Perry Nuclear Power Plant
Docket No. 50-440, License No. NPF-58
EMERGENCY PLAN FOR PERRY NUCLEAR POWER PLANT DOCKET No. 50-440

Pursuant to 10 CFR 50.4, enclosed is a summary of changes for the Perry Nuclear Power Plant (PNPP) EAL Matrix Revision 22.

Perry Nuclear Power Plant PSI-0019 Revision 22 Change Summary

<p style="text-align: center;">PERRY NUCLEAR POWER PLANT</p>	Procedure Number: <p style="text-align: center;">PSI-0019</p>	
Title: <p style="text-align: center;">Emergency Action Level (EAL) Bases Document</p>	Use Category: <p style="text-align: center;">General Skill Reference</p>	
	Revision: <p style="text-align: center;">22</p>	Page: <p style="text-align: center;">1 of 231</p>

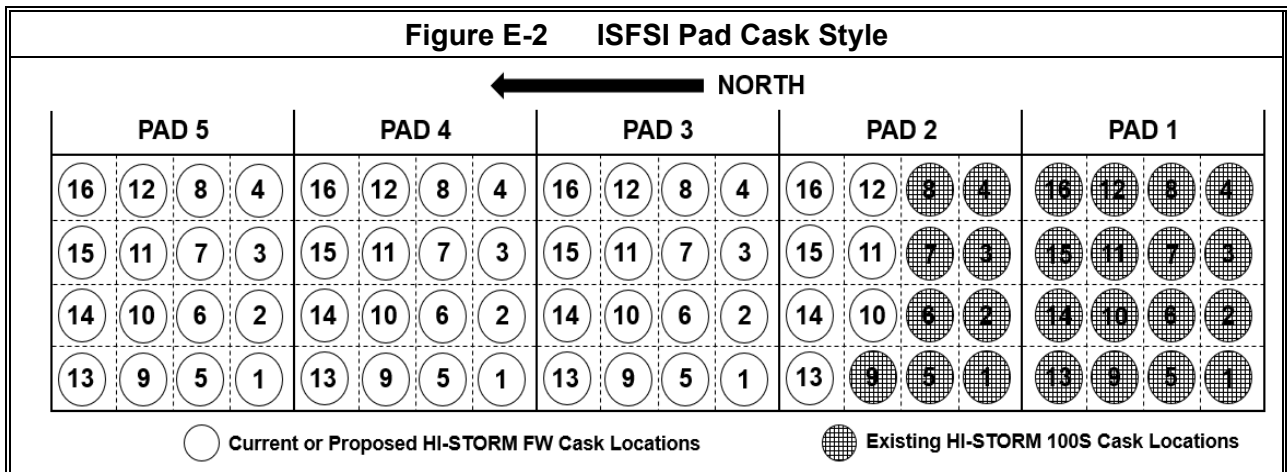
3. Attachment 1: Added Figure E-2, ISFSI Pad Layout, under EAL EU1.1 to identify which fuel casks are the HI-STORM 100S model vice the HI-STORM FW model.

1. The HOLTEC International (HOLTEC) HI-STORM 100 Spent Fuel Dry Storage (SFDS) system which includes the HI-STORM 100S Version B storage cask (overpack) and the MPC-68 multi-purpose canister (MPC). A total of 68 spent fuel assemblies are permitted to be loaded in the MPC-68. A total of 25 loaded HI-STORM 100S casks are stored on the ISFSI Pad as shown in Figure E-2 below.
2. The HOLTEC International (HOLTEC) HI-STORM Flood/Wind (FW) Spent Fuel Storage Cask (SFSC) which consists of the HI-STORM FW cask (overpack) and the MPC-89 multi-purpose canister (MPC). A total of 89 spent fuel assemblies are permitted to be loaded in the MPC-89. Dry fuel casks loaded after 2021 are HI-STORM FW casks (see Figure E-2 below).
